Subject: Hydroprocessed Esters and Fatty Acids (HEFA) Tier1 Calculator

Chevron appreciates the opportunity to review and comment on the Tier 1 Calculators for LCFS pathways.

Appendix A – Comments on the Biodiesel Calculator

Figure 2- Screenshot of Argonne National Laboratory's GREET 2022 model.

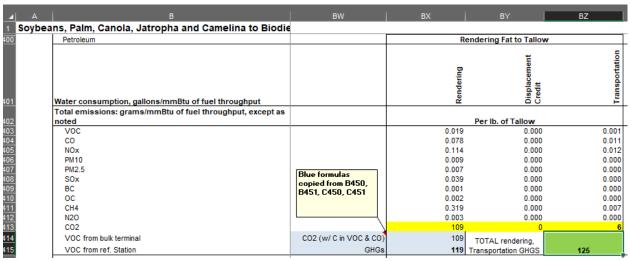
- Tallow's emission factor in the CA-GREET 4.0 calculator of 304 gCO2e/lb ('CA-GREET4.0'!E13) does
 not match the GREET 2022 value of ~125 gCO2e/lb (cells BX413-BZ413 below) when all emissions
 are calculated. CA-GREET 3.0 has a score of ~303 gCO2e/lb ('EF Table'!C43), which aligns with the
 2016 Argonne model number of 308 gCO2e/lb (cells DS314-DU314 below) when all emissions are
 totaled.

- Figure 2 shows a screenshot of ANL's GREET 2022. Note that calculations have been added to GREET 2022, cells BX413 – BZ413 on the BioOil tab (highlighted in yellow). The final CI score is highlighted in green.

CARB's numbers should align with the latest values published in the scientific literature, which we believe are reflected in the latest GREET model. If CARB chooses to use different numbers, we would like to understand the reasoning for the modified values.
